Access Compliance Report

Public Rights-of-Way

(Pedestrian Signals)

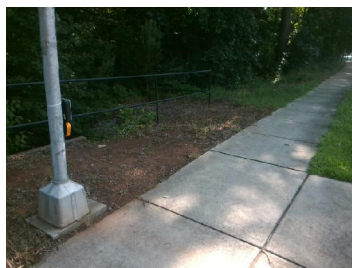
Surveyor Notes: TEXT HT 3/8

PROW/ADA: R410.6, TMUTCD 4e.08

Possible Solutions: Replace Signal Push Button With APS Button on New Post. Remove & Replace Sign.
